# DISTRICT OF SOOKE WWTP EXPANSION PROJECT 2022

## ADDENDUM NO. 4

August 29<sup>th</sup>, 2022

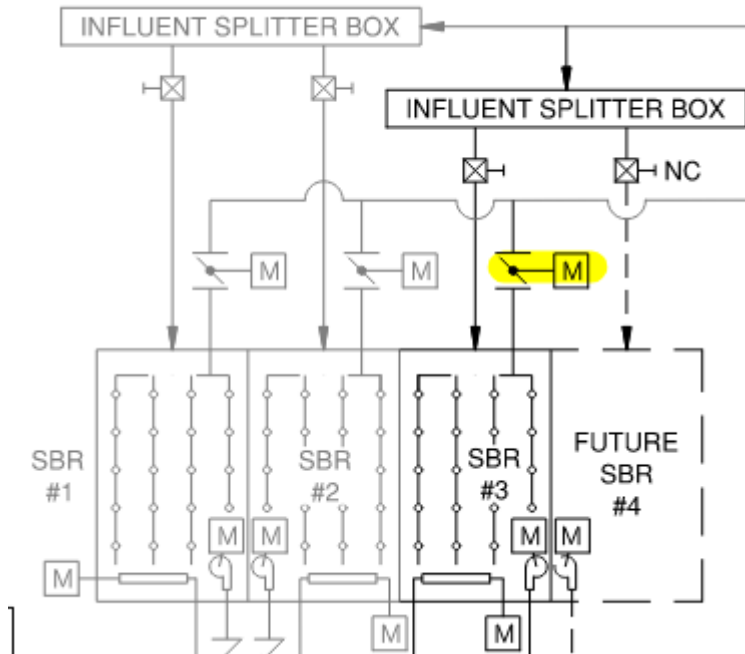
1. Please confirm which valves identified on Drawing P001 are supplied through the novated contracts and which are to be supplied directly by the Contractor. It would be helpful if Drawing P001 had labels identifying who is responsible for each valve.

For example:

Is the check and butterfly valves to SBR Blower #3 to be supplied by the Contractor?

Is the 200 mm motorized butterfly valve below to be supplied by the Contractor?

**Motorized butterfly valve supplied by SBR equipment contractor. Check valve and butterfly valve in blower room by contractor.**

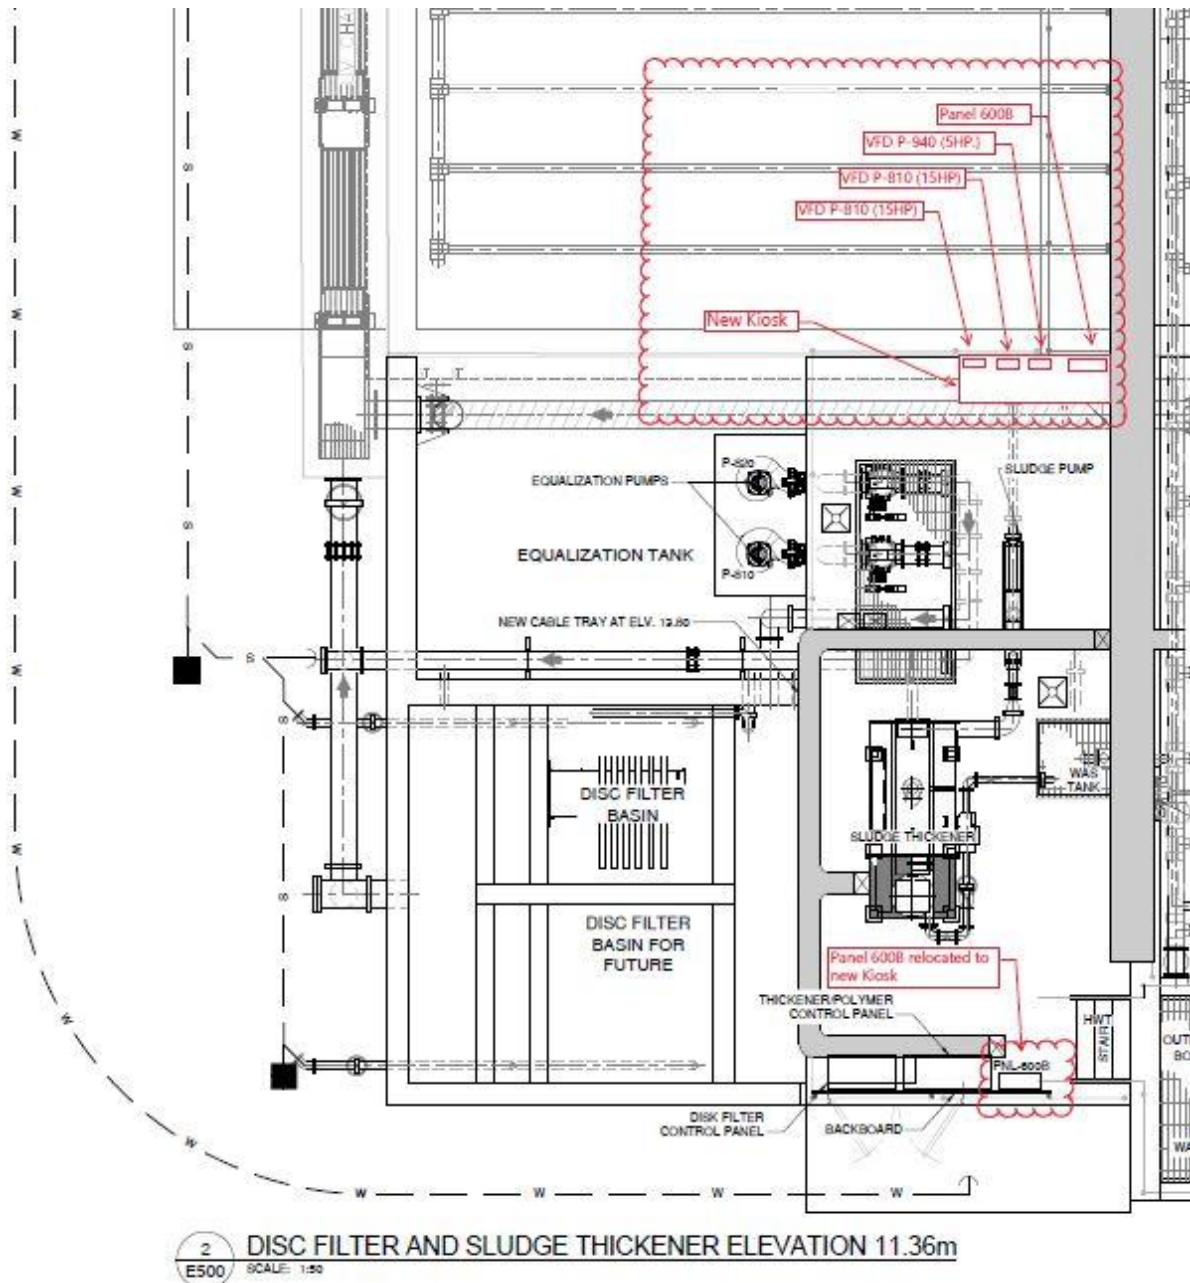
8. The drawings indicate that the 2 Equalization Pumps (P-810 and P-820) and 1 Sludge Thickener Feed Pump (P-910) are to be connected to the new PNL-600B adjacent to Sludge Thickener/Polymer Control Panel. The Sludge Thickener Feed Pump (P-910) is to be fed from the vendor supplied thickener control panel. It is the Thickened Sludge Pump (P-940) that is to be fed from PNL-600B. See further notes and sketch below  
The process drawings also suggest these pumps are to controlled by VFD's. The electrical drawings do not show either starters or VFD's for any of these 3 pumps.

- a. Please confirm the motor control requirements/location for the EQ Pumps and Sludge Thickener Feed Pump.

The contractor is to provide and install a new NEMA 4X Stainless Steel Kiosk enclosure located as shown in the sketch below. The Kiosk is to house new Panel 600B which has been relocated from the Thickener/disk filter panel backboard.

Panel 600B is to be a 18cct 600V panel fitted with the following three breakers.  
A] One (1) 3P 15A breaker to feed the VFD for Thickened Sludge Pump (P-940)  
VFD is anticipated to be 5Hp. P-940 motor size is to be confirmed, as this is an existing owner supplied pump,

B] One (1) 3P 30A breaker to feed Equalization Pump (P-810) the VFD for Equalization Pump (P-810) VFD is to be 15Hp.

C] One (1) 3P 30A breaker to feed Equalization Pump (P-820) the VFD for Equalization Pump (P-820) VFD is to be 15Hp.

The contractor is to supply and install the three VFD's described in items A], B], and C] above within the kiosk and provide the power and control wiring for each VFD consistent with the Type B VFD Schematic shown on Drawing (E-614). The Line Reactor and Long Lead Filters for each of these drives are not required. the operator panel is to be integral to the drive, and each pump will be fitted with a local control station that includes the L/O/R selector switch and a local speed control pot.

Provide 3C + Gnd #12 Teck cable to power Thickened Sludge Pump (P-940). Co-ordinate with Equalization Pump Vendor to supply sufficient pump cable length to route from the Equalization Pumps (P-810 and P-820) to the VFD's with out need for a splice or field junction box.
